DATE: May 3, 2017
TO: All Prospective Bidders
FROM: Randy Mendenhall, P.E.
RE: Buchanan County Bridge BRO-B011(30)
Buchanan County, Missouri
Addendum No. 1

Addendum No. 1

**Buchanan County Bridge
BRO-B011(30)**

PROJECT NAME: BUCHANAN COUNTY BRO-B011(30) BRIDGE NO. 2570001		SCALE: NONE
SHEET REFERENCE: 5 OF 19		DATE: 05/02/17
SNYDER & ASSOCIATES, INC.		PROJECT #: 116.0142.11
ADDENDUM #: 1

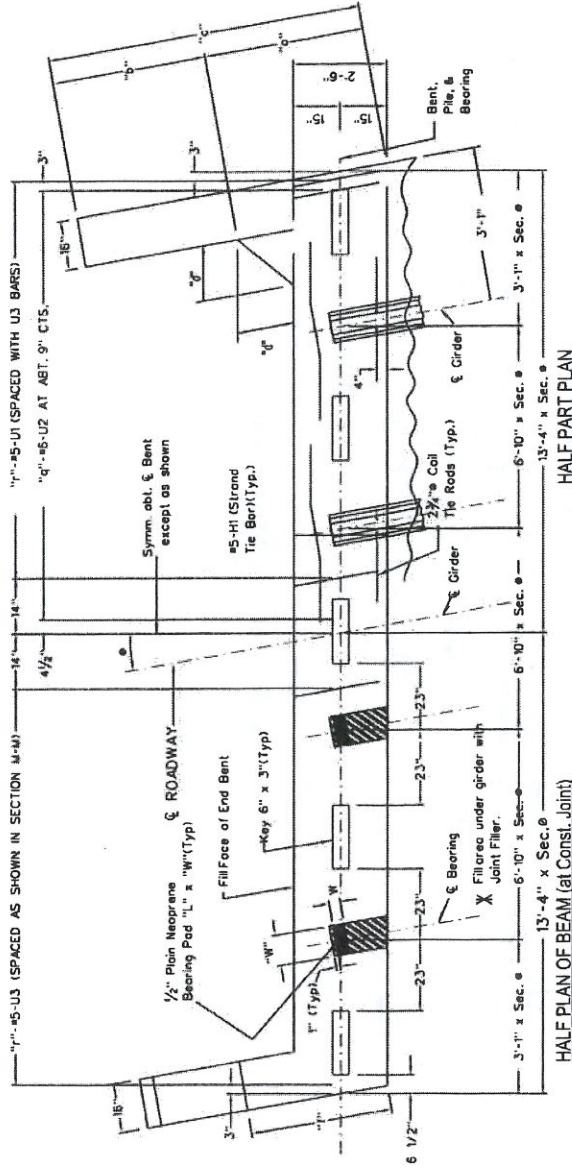
1. **Sheet 5:** Replace the half plan detail of the end abutment with the detail shown in the attached exhibit. The girder layout has been corrected in this detail.
2. **Sheet 7:** Replace the detail showing the 'SECTION NEAR END BENT' with the attached exhibit. The girder spacing has been adjusted in the revised detail.
